REAR SHOCK LOCKNUT TIGHTENING PROCEDURE

The purpose of this bulletin is to provide a revised torque specification and additional instructions required for proper tightening of rear shock adjusting locknuts. This bulletin also announces the release of two **new** tools to support this procedure. The **new** tools (Part No. B-45110) are scheduled to be available on or before December 11, 2000 and will be shipped to your dealership free of charge. Dimensions for the preload adjusting nut and locknut have been provided should tool fabrication be required.

Figure 1. Locknut Tightening Procedure

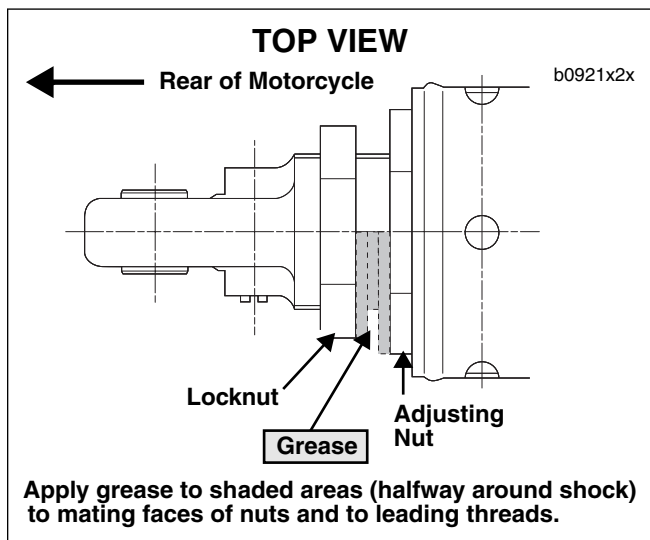
1. See Figure 2. Inspect shock absorber compression adjuster screw area for BLUE or GREEN paint mark. If no paint mark is found, continue with Step 2.
2. Back locknut off a few turns from its tightened position.
3. See Figure 1. Apply wheel bearing grease halfway around the shock (180 degrees) to the mating faces of the locknut and adjuster nut and the first few threads on the aluminum body leading to the adjuster nut.
4. Thread locknut back into place.

Torque wrench and locknut crow's foot must be set at 90 degrees to prevent torque multiplication by wrench.

5. Using SHOCK PRELOAD ADJUSTING TOOLS (Part No. B-45110), hold adjusting nut in place with 60 mm ADJUSTING NUT WRENCH and tighten locknut to 65-72 ft-lbs (88-98 Nm) with 52 mm LOCKNUT CROW'S FOOT set at 90 degrees to the torque wrench.
6. Wipe excess grease off of shock absorber.
7. See Figure 2. With a BLUE paint marker, mark shock on aluminum neck, next to the compression adjuster screw. This will identify the shock as having had this procedure performed.

Figure 2. Paint Mark Location(s)/Final Tightening

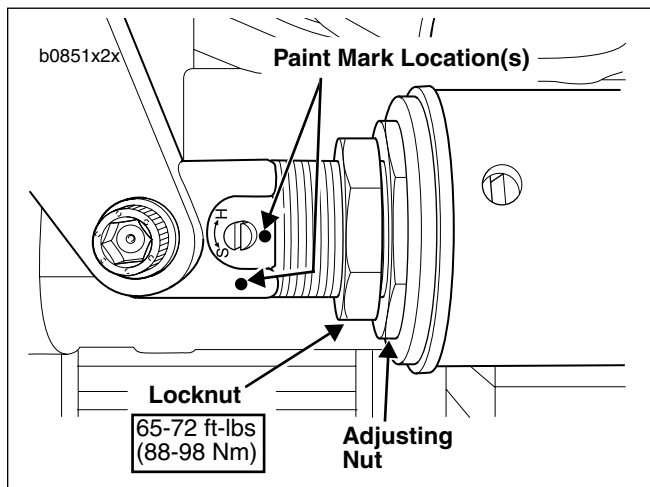
To ensure the proper clamp load on the locknut that secures the spring adjusting nut of the rear shock, the following procedure must be performed now, and each time the locknut is loosened to adjust preload. Shocks that have had this procedure performed will have a BLUE or GREEN paint mark next to the compression adjuster.
